**RE: Sanderway  
Carrboro, North Carolina  
SPEC-18092**

*McAdams was tasked with reviewing the stormwater design calculations and construction drawings provided to us by Jeff Kleaveland from the Town of Carrboro on August 30<sup>th</sup>, 2018. The purpose of this review was to determine how/if the Sanderway development meets the Town of Carrboro stormwater rules and to determine what analyses were performed to ensure the downstream neighbors will not be adversely impacted by the proposed Sanderway development. The following questions/comments were generated from the review and require additional information to ensure all applicable requirements are being met for the proposed development:*

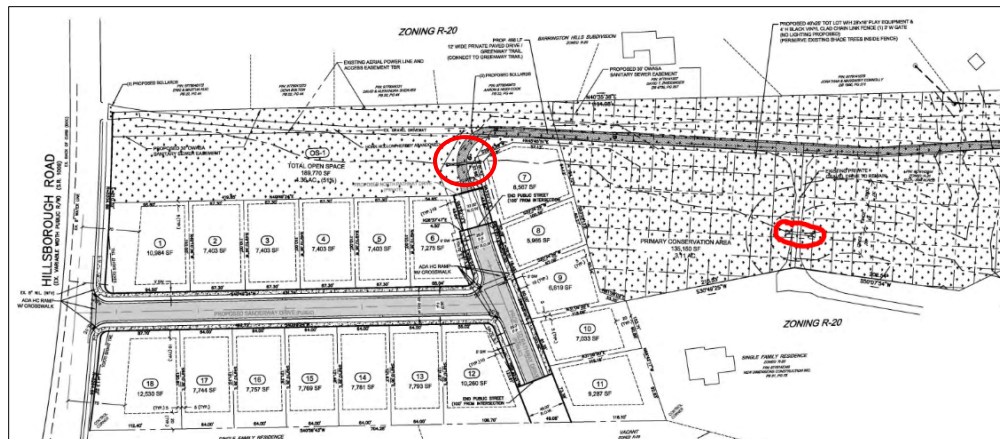
- Is there a detention exemption for the site that gets the proposed development out of 1-, 2-, 5-, 10-, and 25-year storm peak flow detention? No hydrograph analysis has been presented for review to back up the detention requirements of the ordinance.
- No information was provided to support a peak flow analysis was completed at the locations circled below and where runoff leaves the Sanderway property.

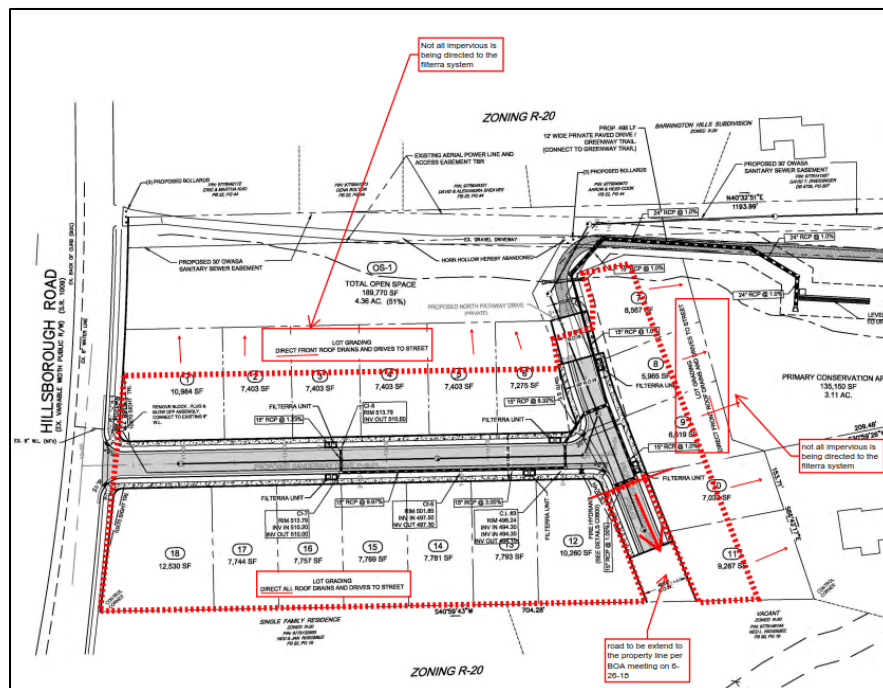
- No calculations are provided to support 85% average annual removal rate for Total Suspended Solids (TSS)
- No bypass impervious is shown in the SNAP tool, although the utility plan (sheet C0300) mentions that some areas will only take the front roof drains to the system (impervious areas on site are bypassed and do not enter the stormwater treatment system).

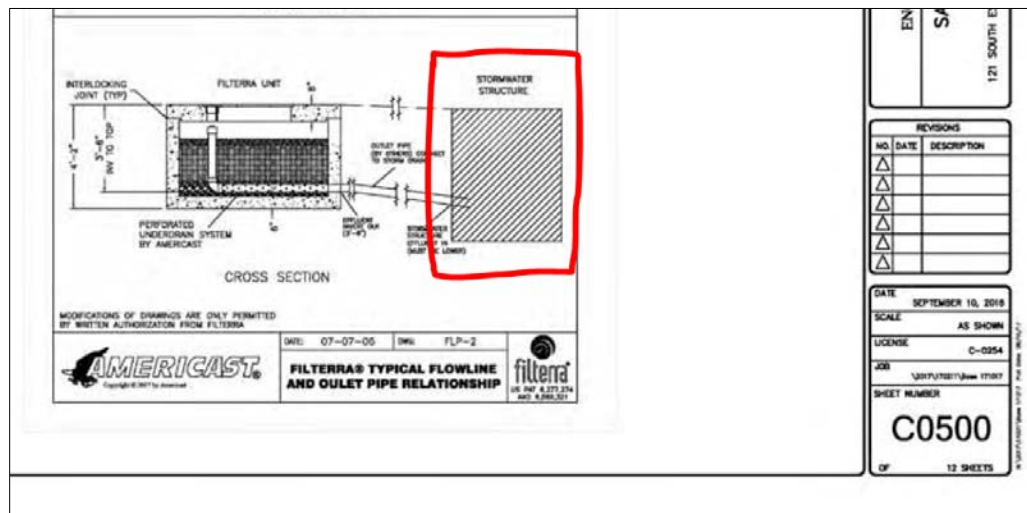
- No calculations were provided to show the “preexisting Composite Curve Number” that was used to determine the “Maximum allowable increase in annual stormwater runoff volume.”

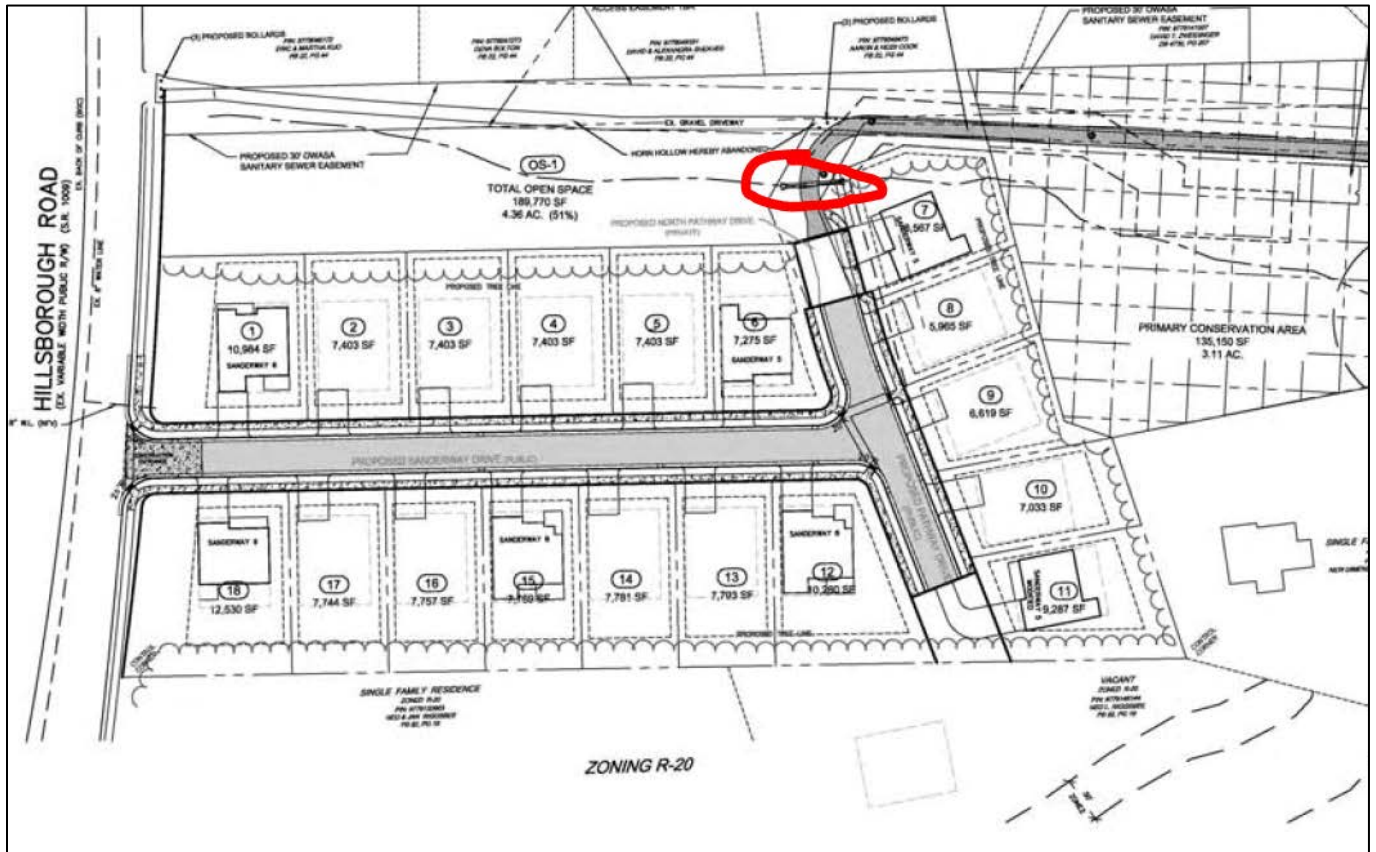
- Is the existing 12" culvert where Sanderway connects to the greenway being replaced? Not labeled on plans
